Amendments to the Drawings:

"SEAT LOAD MEASURING APPARATUS"

S.N. 10/822,706

Fig. 6(A)*Fig. 6(B)**Fig. 6(C)**Fig. 6(D)*

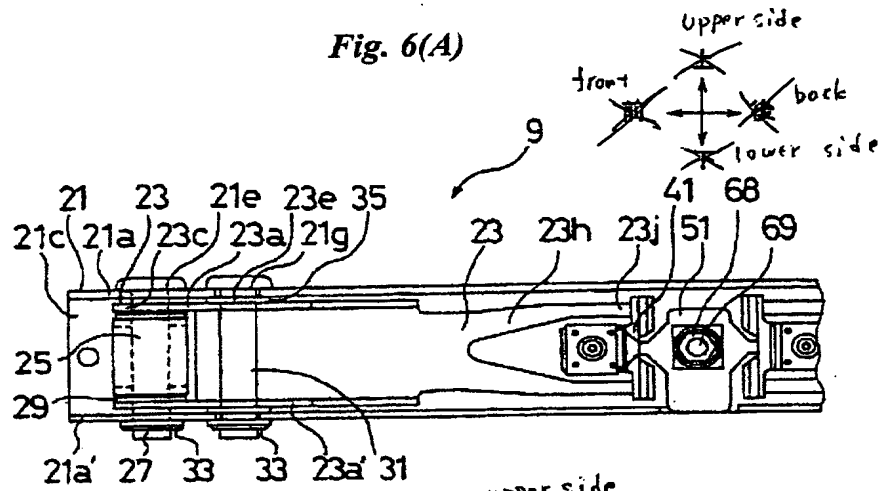
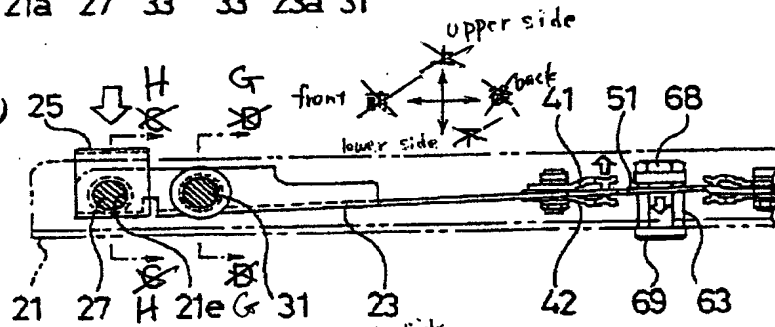
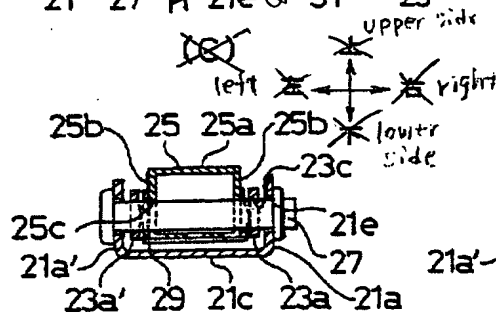
The drawings have been objected to because the reference characters "C-C" and "D-D" have been used to designate cross-sections in FIGS. 2(B), 3(B), and 6(B) and cross-section designations can only be done for one picture at a time. Amended drawings have been submitted in which the cross-section designations in FIGS. 3(B) and 6(B) have been changed. Annotated drawings have also been submitted showing the changes.

The drawing sheets attached in connection with the above-identified application containing Figures 3(A) to 3(B), 5(A) to 5(B), and 6(A) to 6(D) are being presented as sheets to be substituted for the previously submitted drawing sheets. Figures 3(B) and 6(A) to 6(D) have been amended. Appended to this amendment is an annotated copy of the previous drawing sheet, which has been marked to show changes presented in the replacement sheet of the drawing.
